Name of Proposed Subdivision HARBOR PHASE ONE

PRELIMINARY/FINAL PLAT

P&Z 88-16-FP - Discuss and Consider Approval of a Request from Whittle Development for a Final Plat on The Harbor Phase I

# Harbor Phase I Final Plat

**1st (SUBMISSION)**

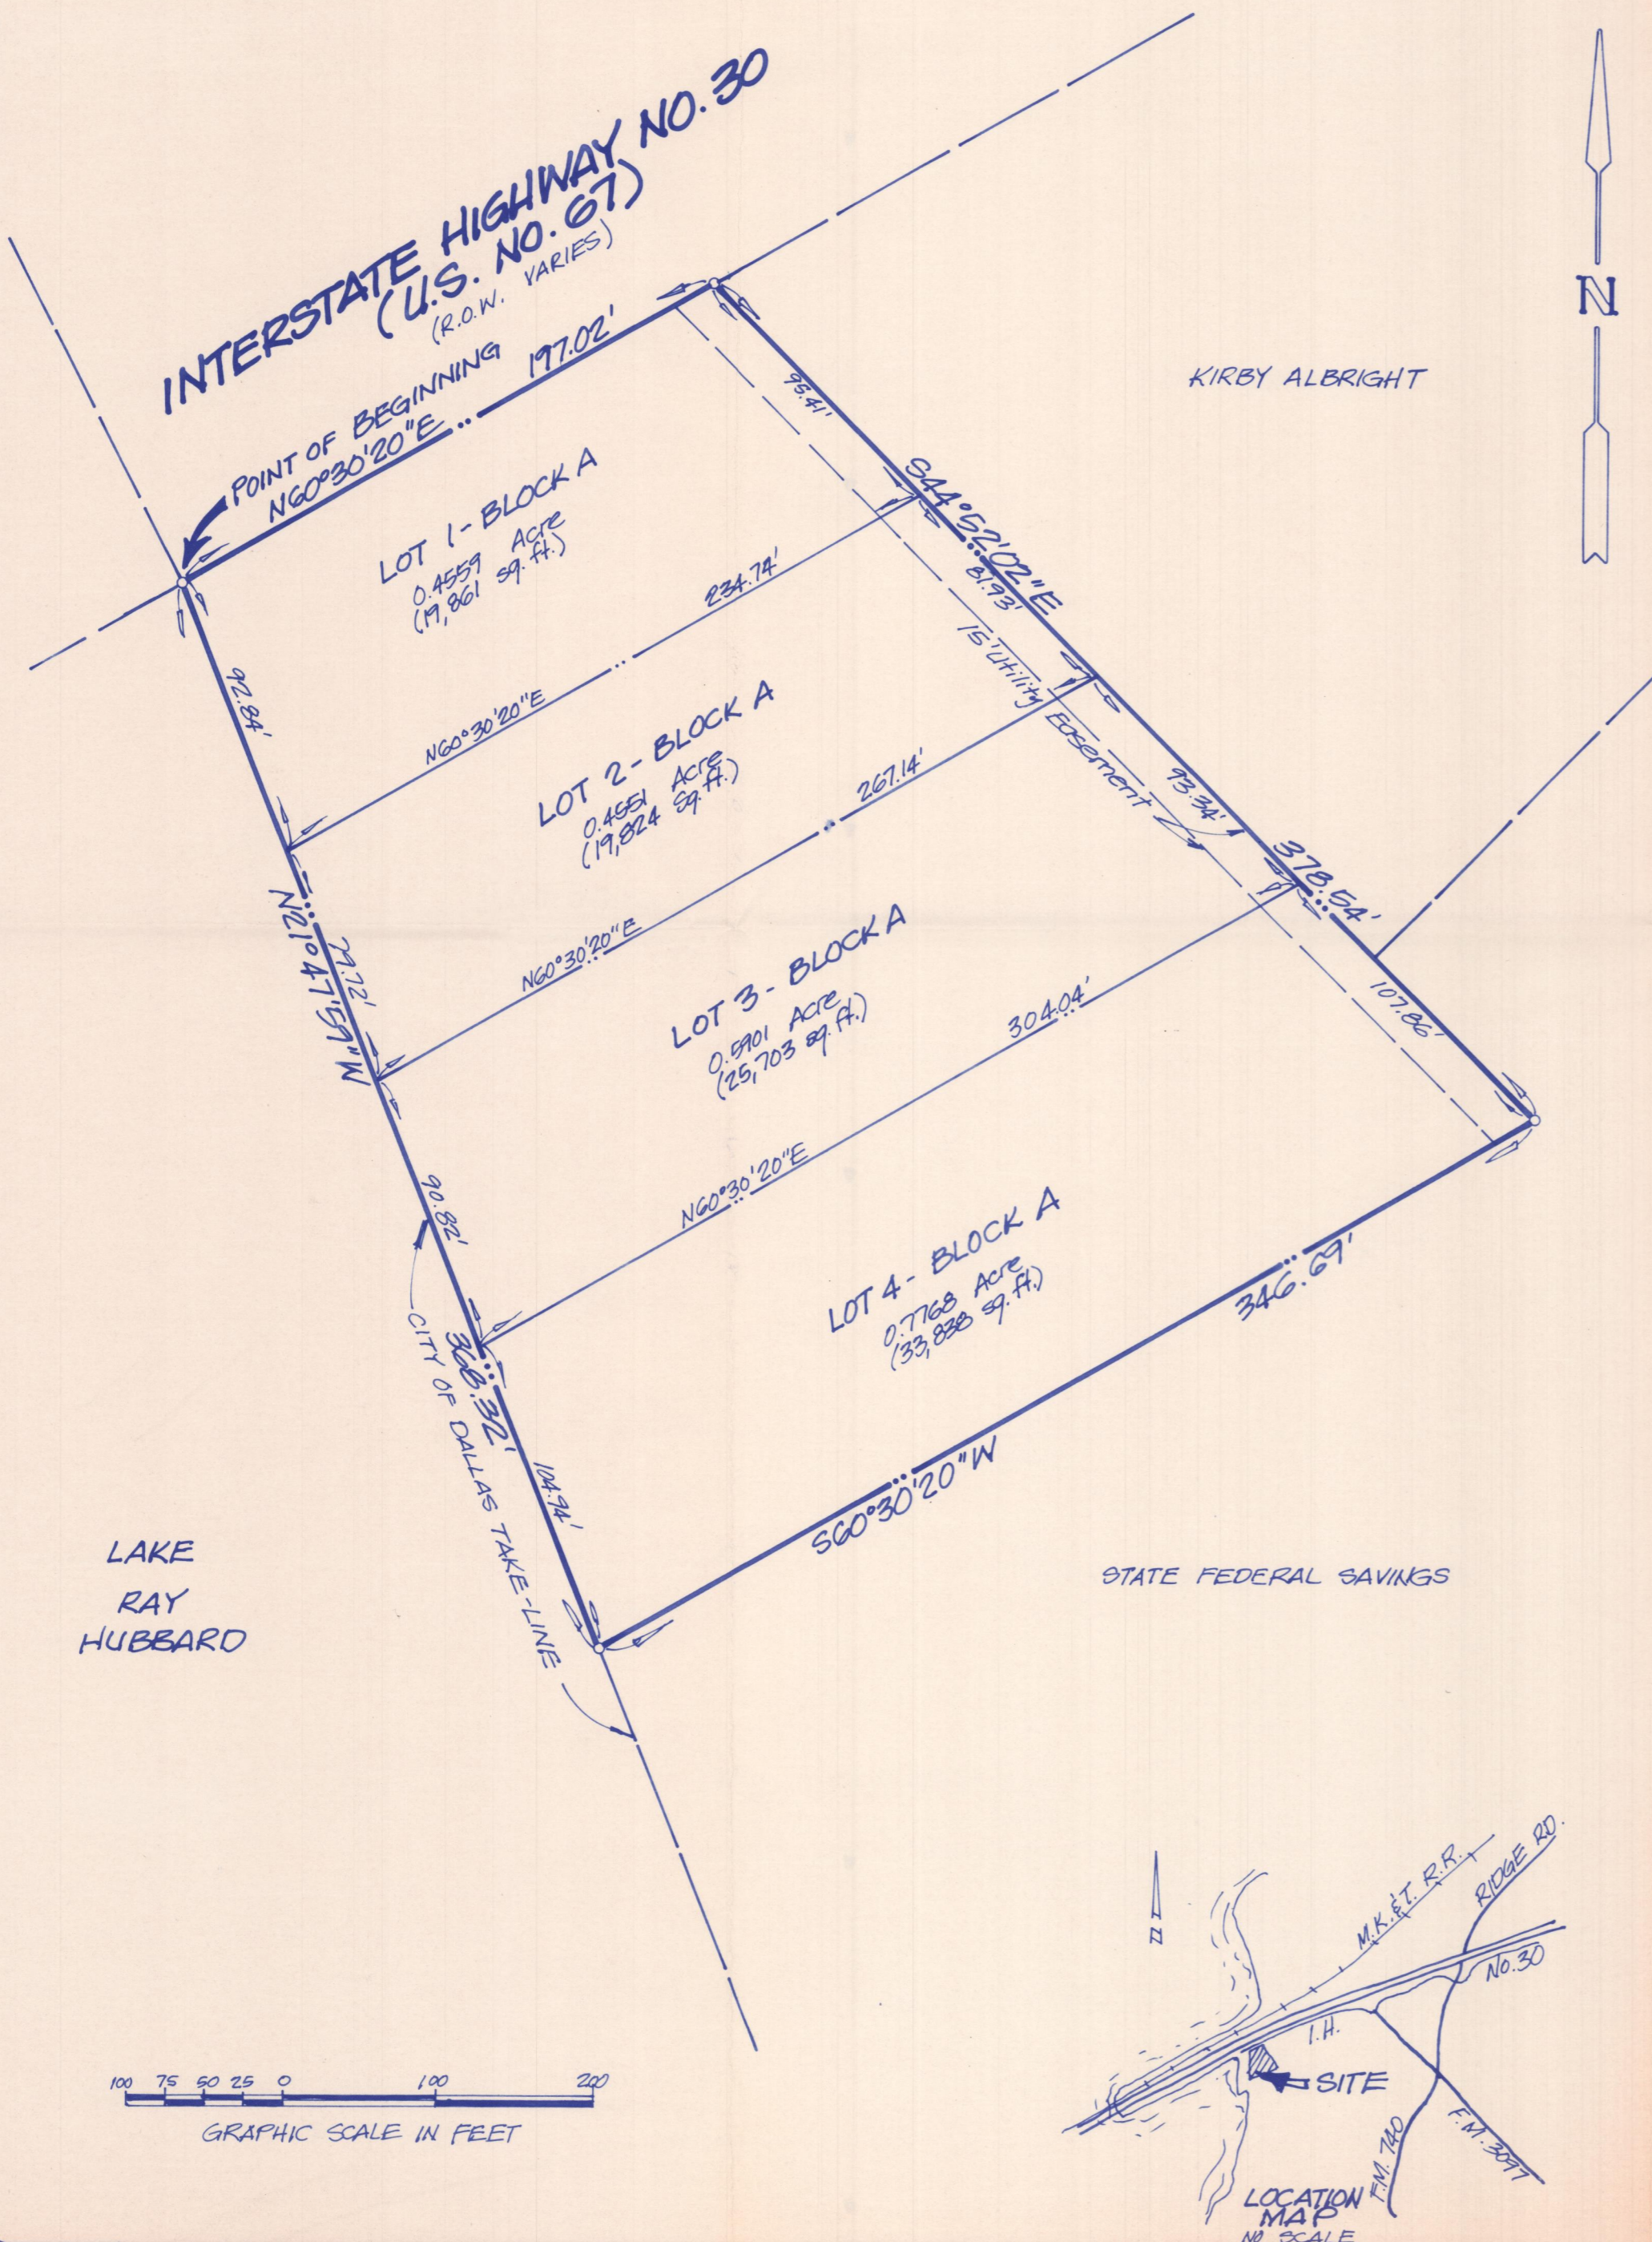
11. Does plan conform to the Comprehensive Zoning Ordinance of approved PD Ordinance?			
a. Lot Size <i>one lot is not correct in dimensions</i>	<input type="checkbox"/>	<input checked="" type="checkbox"/>	<input type="checkbox"/>

*only with dedicated access easements*

1. Approval of a variance to the minimum lot frontage requirements by the Board of Adjustments
2. Correction of drive width from 20 feet to 24 feet
3. Specific language will be added to the plat regarding future access easements necessary for the remaining undeveloped lots

1. Access easements need to be shown on all drive lanes across all 4 lots. These are currently being added and should be presented at the meeting Thursday night.
2. The property owner has made application to the Board of Adjustment for a variance to the lot width along I-30 because it is approximately 2.6 feet less than the required 200 feet. This is all the land the developer owns and he cannot meet the requirement to the letter. Any approval should be conditioned on approval of the variance by the Board.

**3rd (SUBMISSION)**

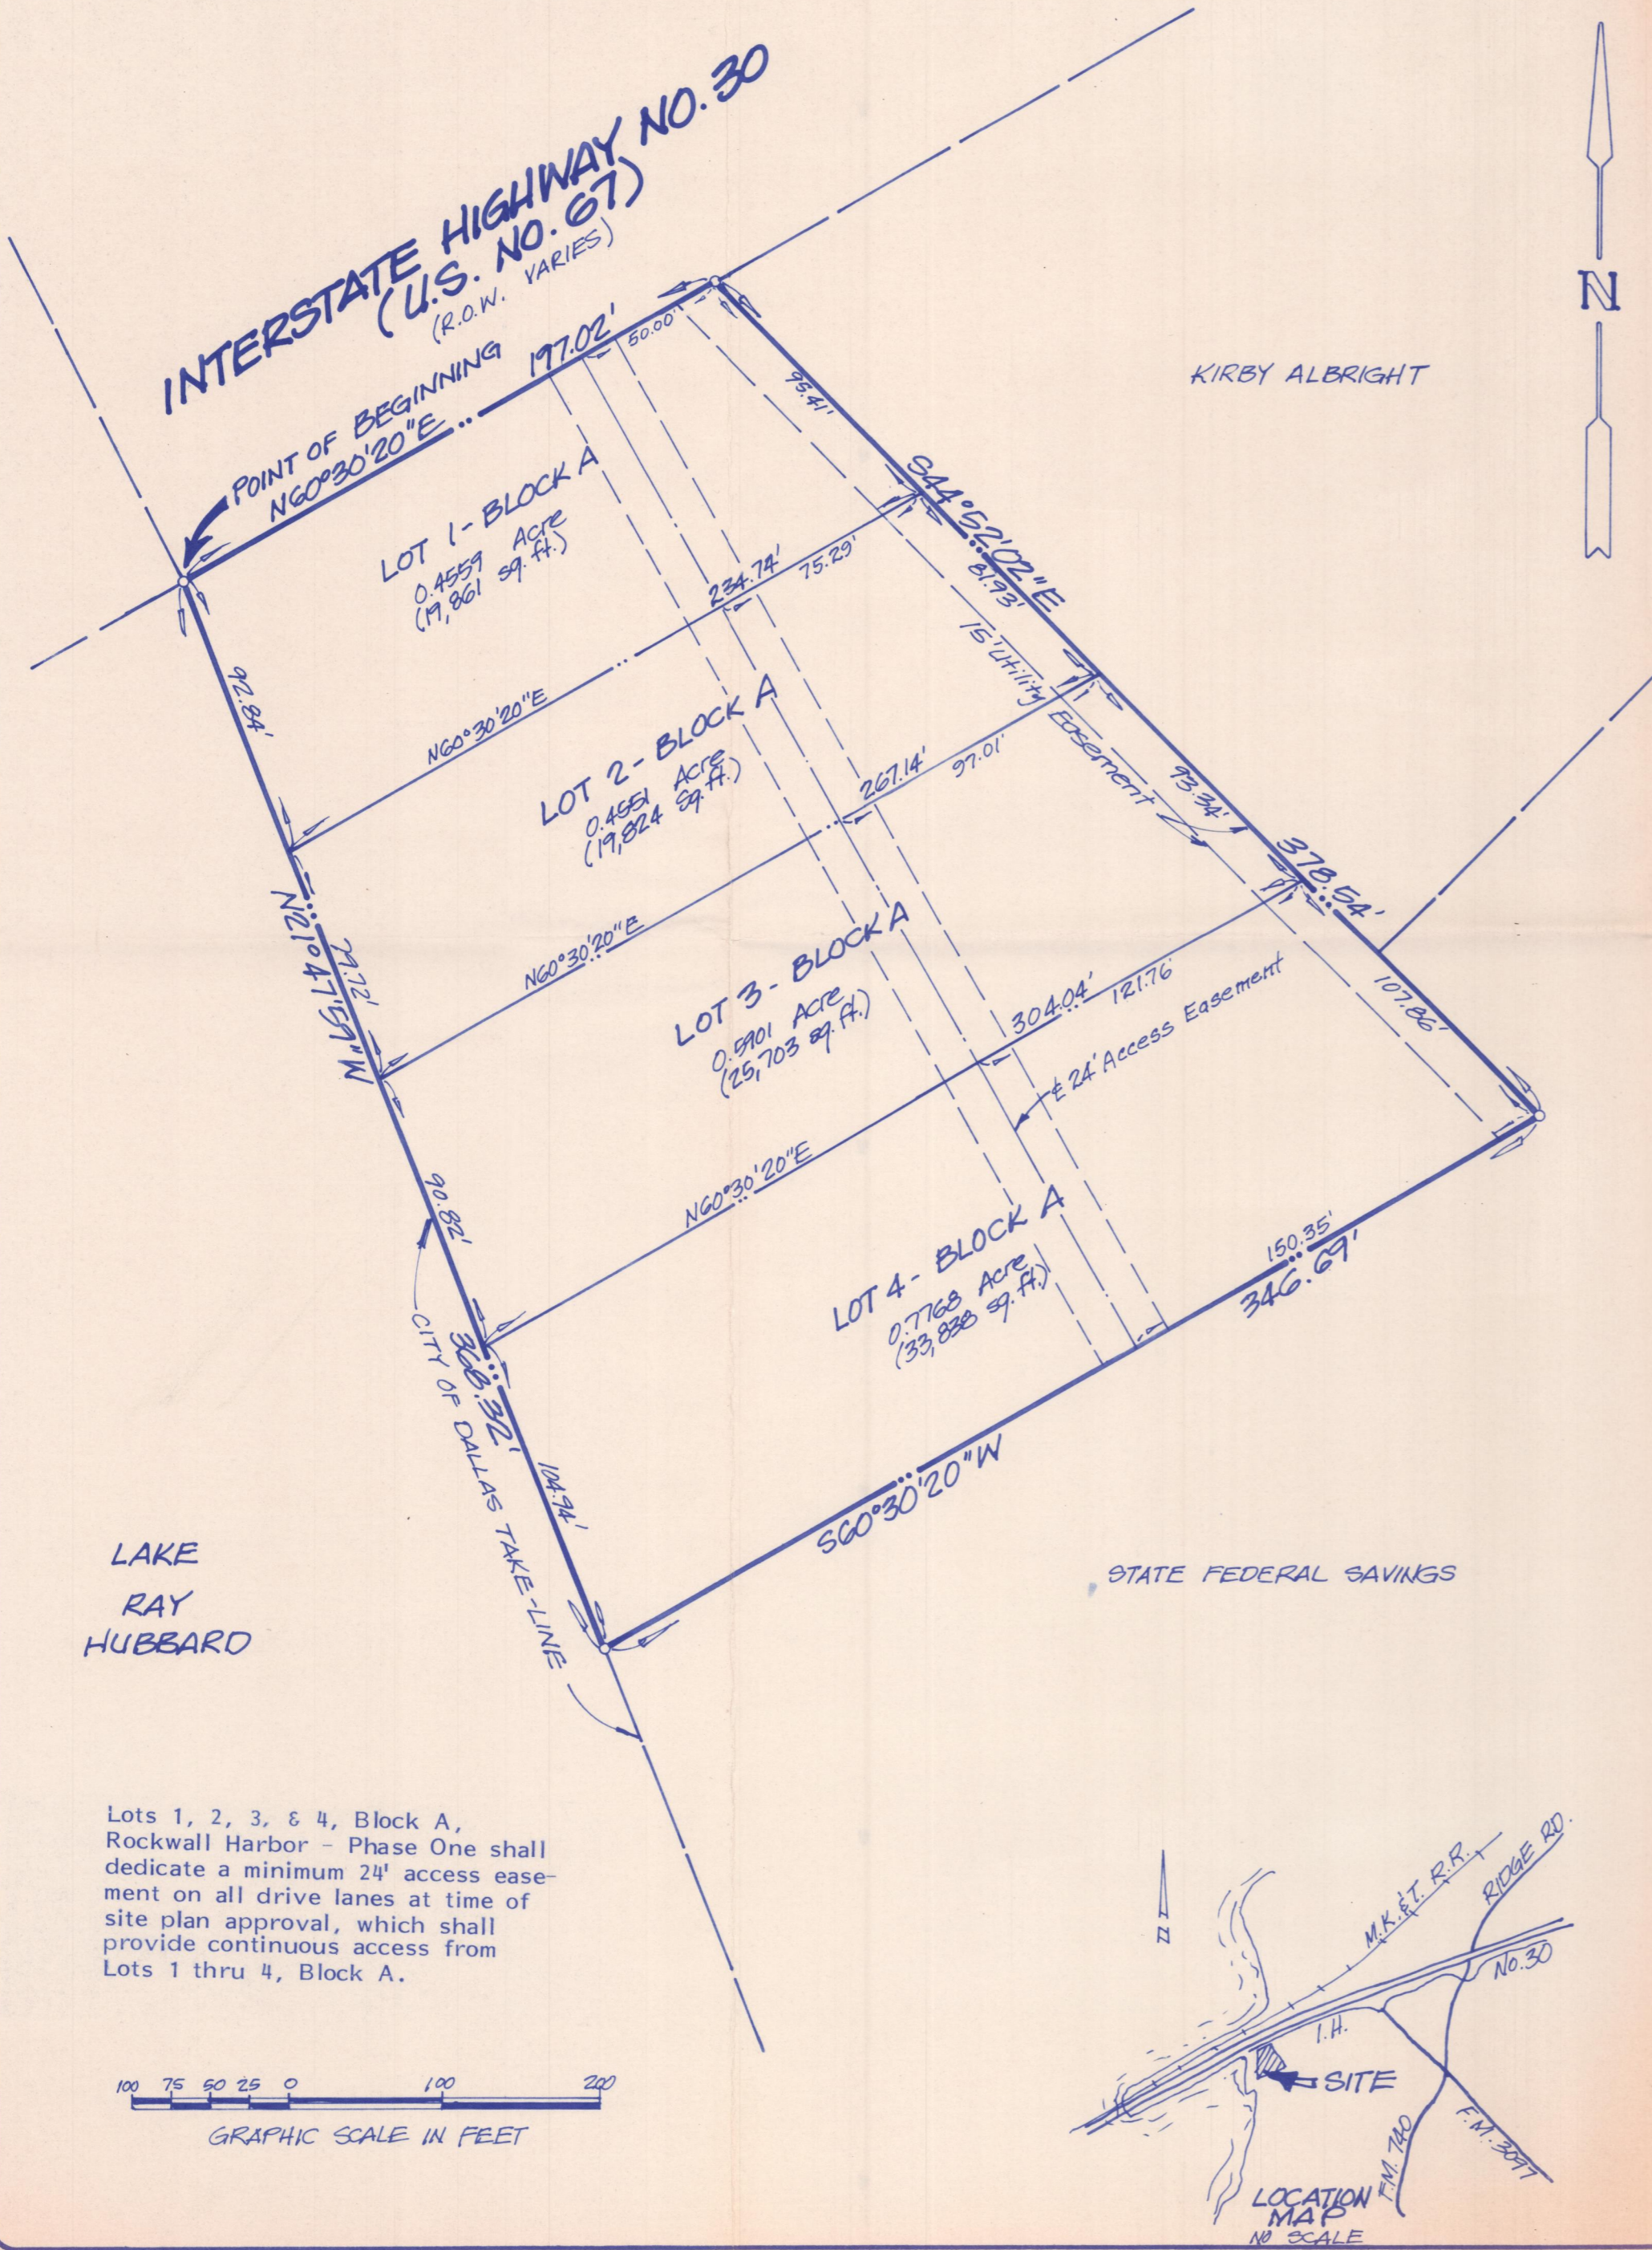
5. Cross access easements need to be dedicated on all drive lanes on plat

The Commission then considered approval of a final plat for the Harbor, Phase I. Couch explained that cross access easements needed to be provided at all three drives but the developer was concerned about tying down the location of the drives prior to having a business committed to the site. She explained that there was some language necessary on the plat to require future access easements. The Commission discussed the drive locations, and the developer's application to the Board of adjustments for a variance to the 200 foot log frontage requirement. Sinclair made a motion to approve the final plat subject to the addition of necessary language regarding future cross access easements, correction of the typographical error indicating a 20 foot drive to 24 feet, and approval of the variance by the Board of Adjustments. Crumbley seconded the motion. The motion was voted on and passed unanimously.

Conditions review at 4/28 worksession, approval by BOA,  
correct 20' to 24' diene
